RS-01-303

Subject: Revision to Proprietary Designation - Additional Plant Systems Information
Supporting the License Amendment Request to Permit Up-rated Power
Operation, Dresden Nuclear Power Station and Quad Cities Nuclear
Power Station

Additional Plant Systems Information Supporting the License Amendment Request to
Permit Upgraded Power Operation (non-proprietary version)

Figure 9-1
DNPS Short Term Core Spray NPSH

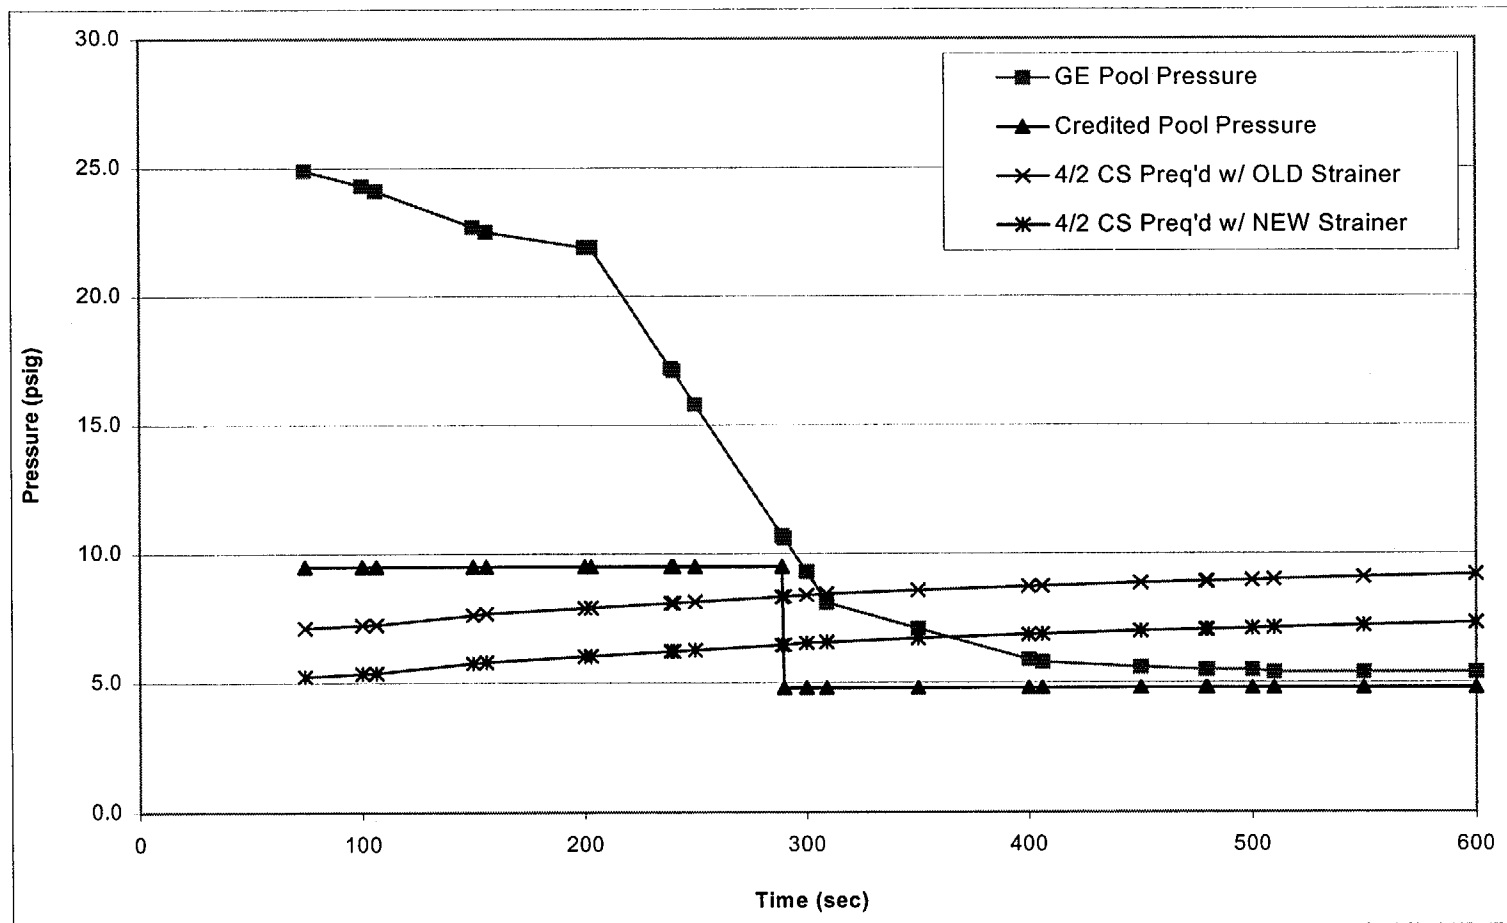
9. Provide the emergency core cooling system (ECCS) pumps net positive suction head (NPSH) calculations to support the requested additional credit for overpressure. Discuss the increased need for containment overpressure for NPSH following a design basis accident. Describe the procedures or equipment in place that will allow continued cooling flow with the drywell potentially depressurized to atmospheric conditions and the suppression chamber at the most conservative pressure associated with vacuum breaker operation (limiting case either torus/drywell or torus/reactor building). Additionally, discuss the methodology for determining the requested containment overpressure, including the headloss across the ECCS suction strainers.

The graphs showing the results of the ECCS NPSH calculations for the limiting short term and long term flow cases are provided in Figures 9-1 and 9-2. Core spray flow is the limiting NPSH case in the short term, and LPCI flow is limiting for NPSH in the long term. Figures 9-1 and 9-2 also show NPSH required (NPSHr) for both the old strainer and new strainer cases (e.g., one blocked, three clean). The higher head loss of the old strainers, as indicated above, is the basis for the requested overpressure.

In the short term, there is a period from approximately 290 seconds to 600 seconds during which some ECCS pump cavitation can occur, since the available NPSH is less than the required NPSH. This period is after the time at which the peak cladding temperature (PCT) has been reached at approximately 240 seconds. Prior to 290 seconds, the requested overpressure ensures that adequate NPSH is available to meet the core cooling requirements assumed in the PCT calculations. After 600 seconds, ECCS pump throttling restores adequate NPSH. Pump cavitation for the brief time from 290 seconds to 600 seconds is not of concern due to short duration of the cavitation.
